BPDA Design Review Provisos
43-45 Mount Vernon Street, Charlestown
6/4/2024

PROPOSED ADDITION & RENOVATION 43 MOUNT VERNON STREET, CHARLESTOWN, MASSACHUSETTS

**PROPOSED ADDITION &
 RENOVATION
 45 MOUNT VERNON STREET
 CHARLESTOWN, MA 02129**

APPROVED PROPOSED FRONT ELEVATION
 DESIGN REVIEW
 BOSTON REDEVELOPMENT AUTHORITY
 1/8" = 1'-0"
 APPROVED 06/04/2024
 SIGNATURE *Scott P...*

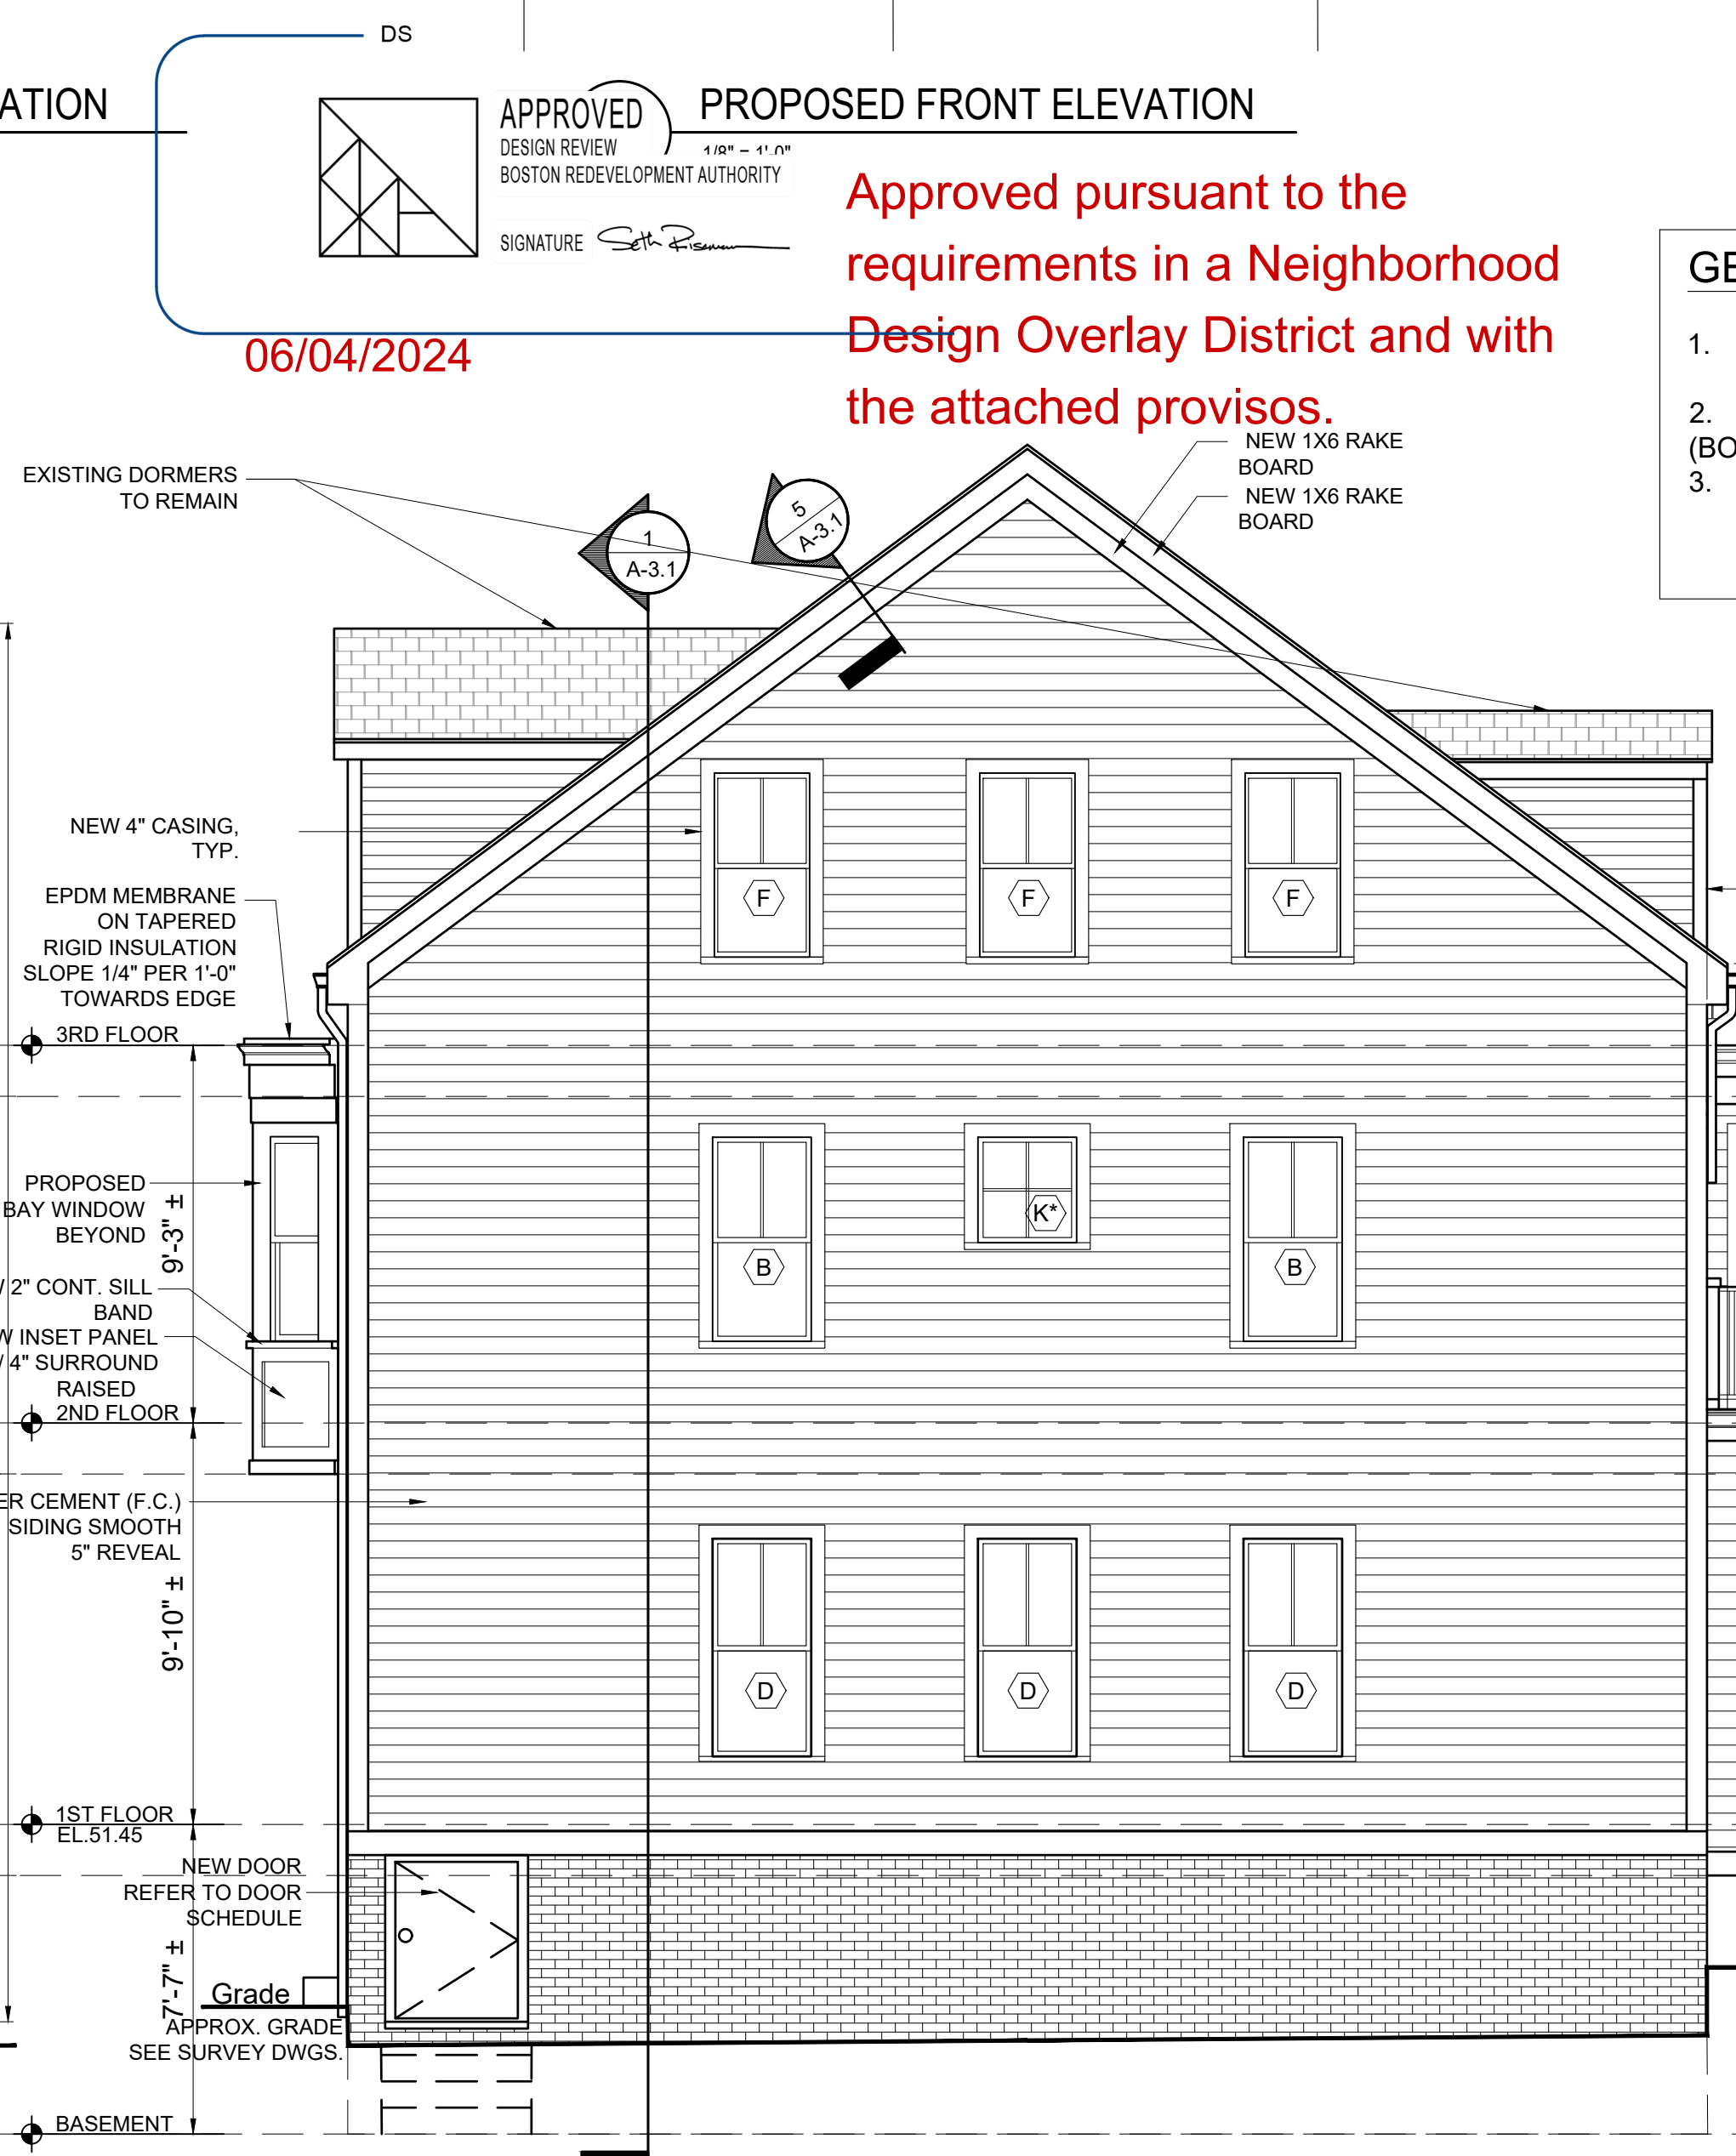
Approved pursuant to the requirements in a Neighborhood Design Overlay District and with the attached provisos.
